Asset Walk 6-9 weeks

Project:3501 Spec Suite 180

① LEVEL 01 MECHANICAL PLAN

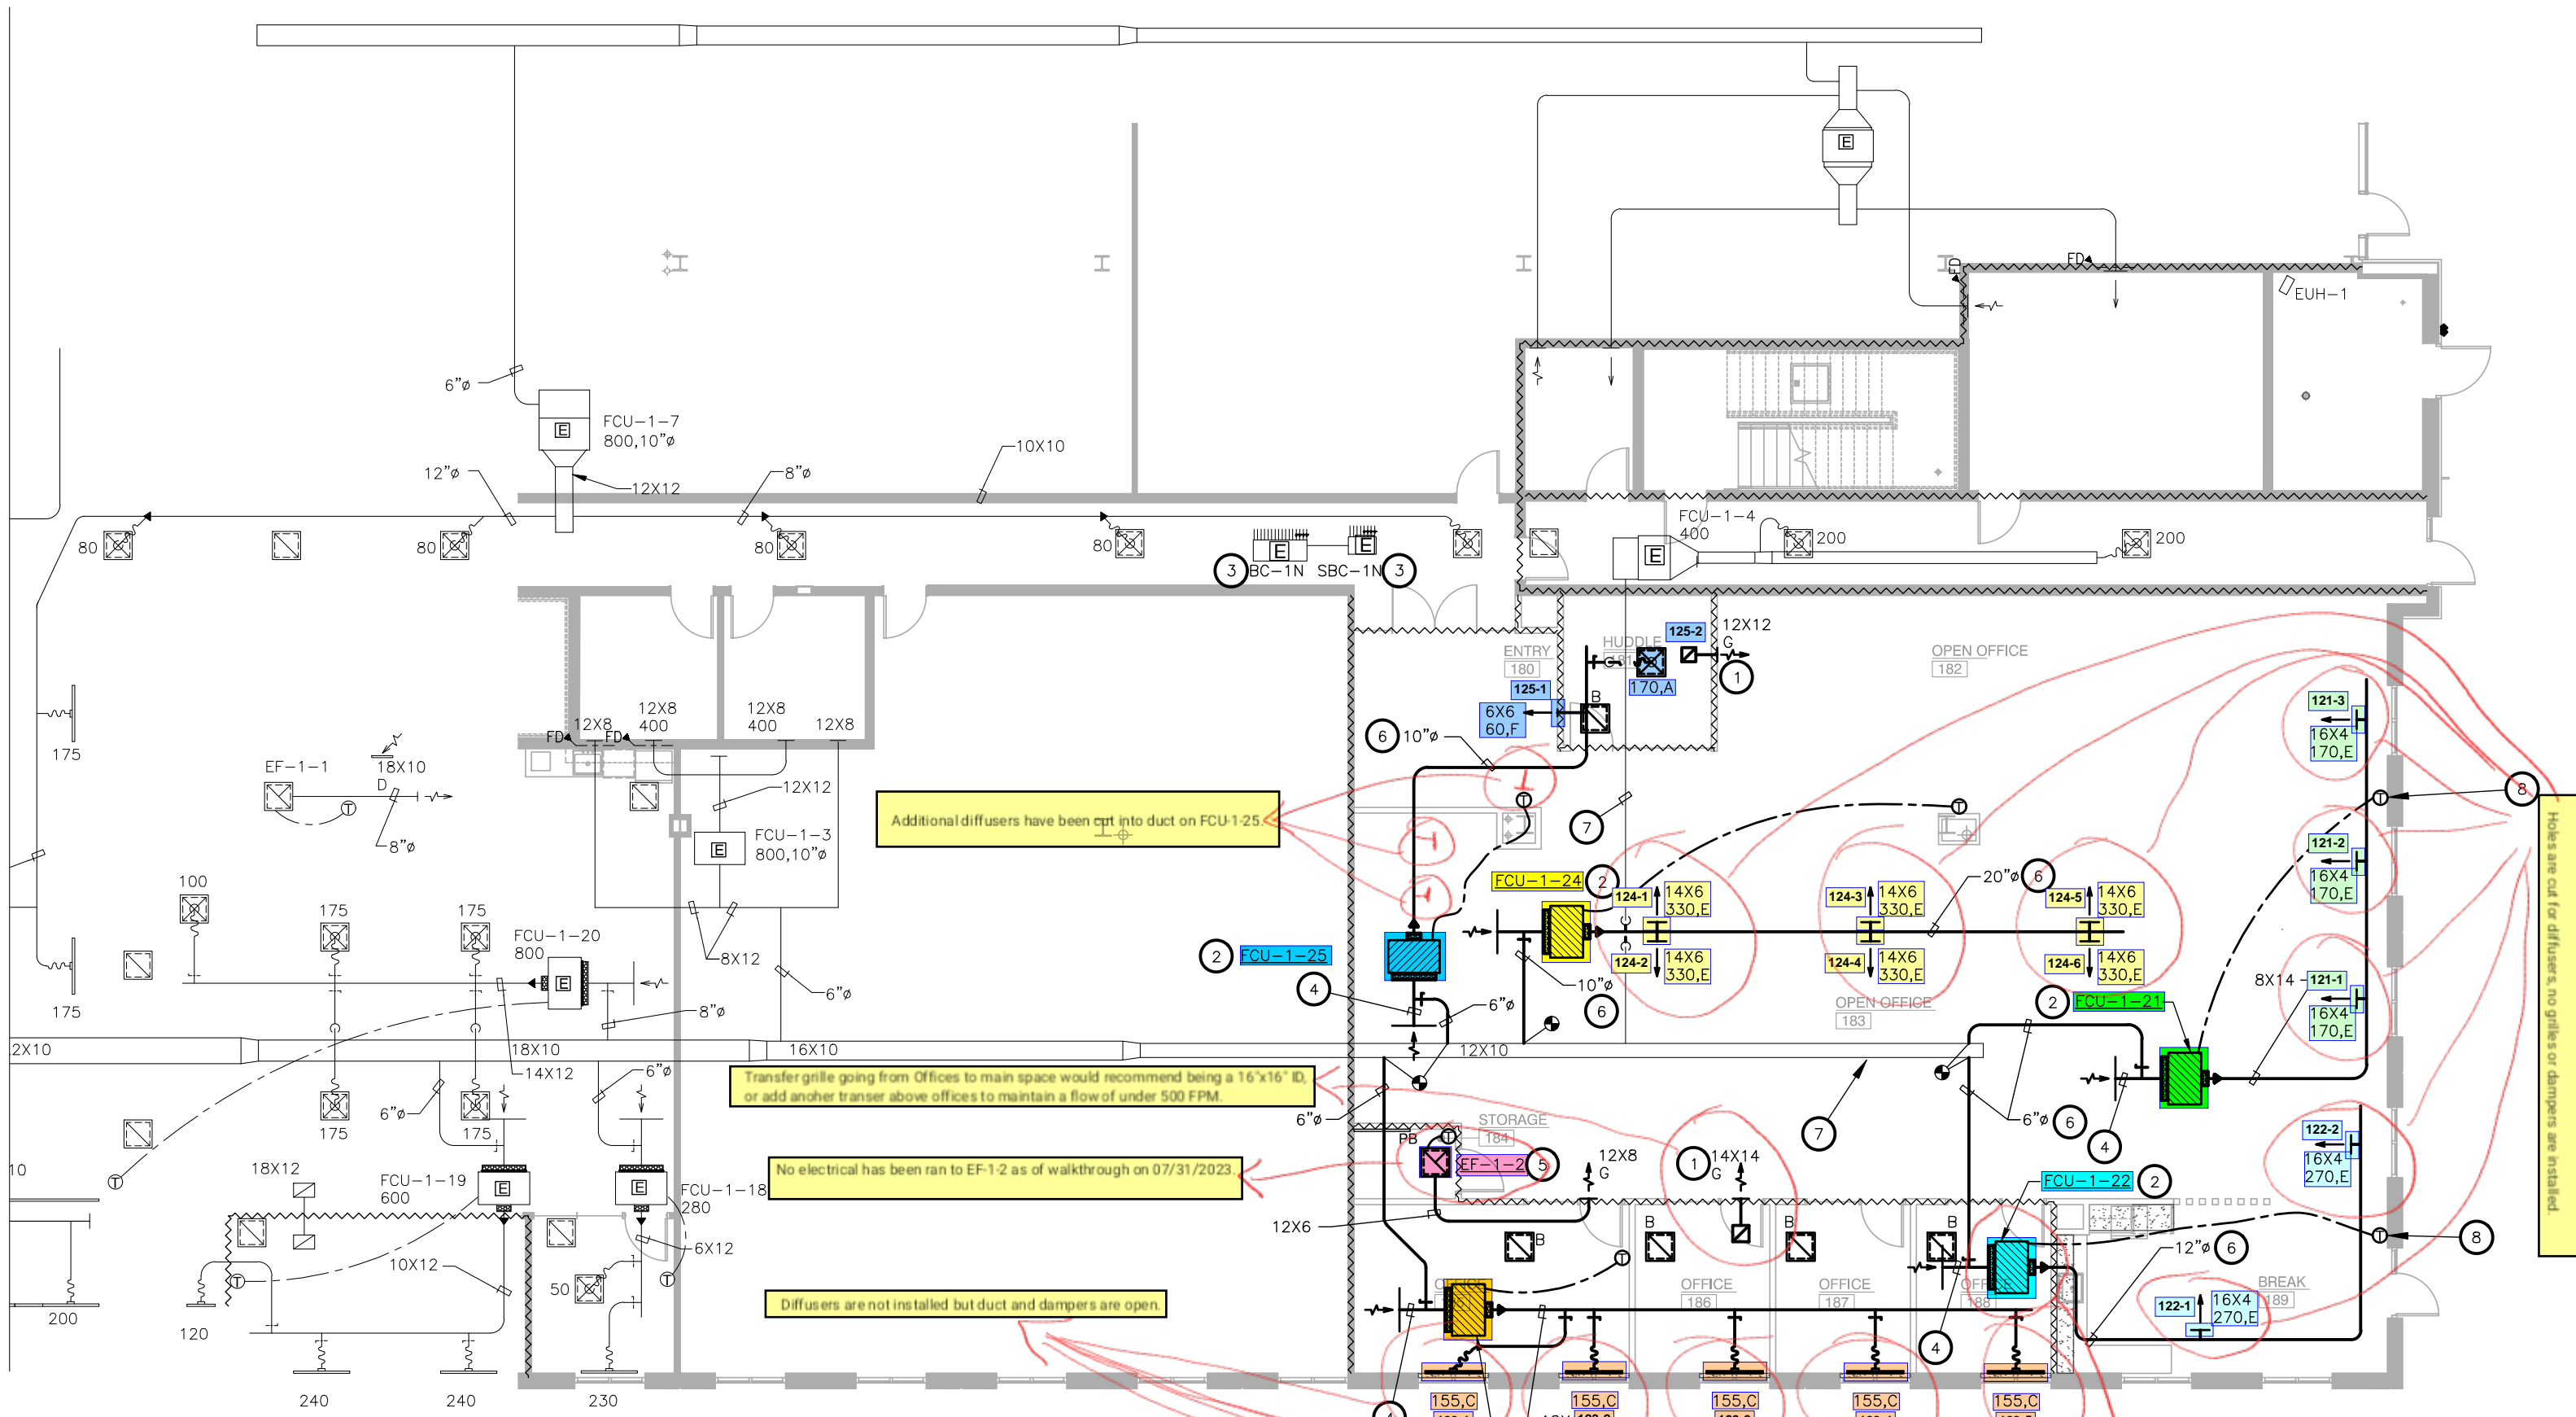
Are they in the correct location	Yes.
Comments	See plans for recommendation of office transfer grilles.
VAVs	
VAV Hanging & Present	None.
Inlet Duct connected	None.
Discharge Duct connected	None.
Unit Powered & Operational	None.
Piping to reheat coil complete	None.
Balance dampers installed and open	None.
Comments

775
570 FPM
1.36

FCU-1-22 appears to have been taken out and duct from FCU-1-23 continues to serve FCU-1-22 area.
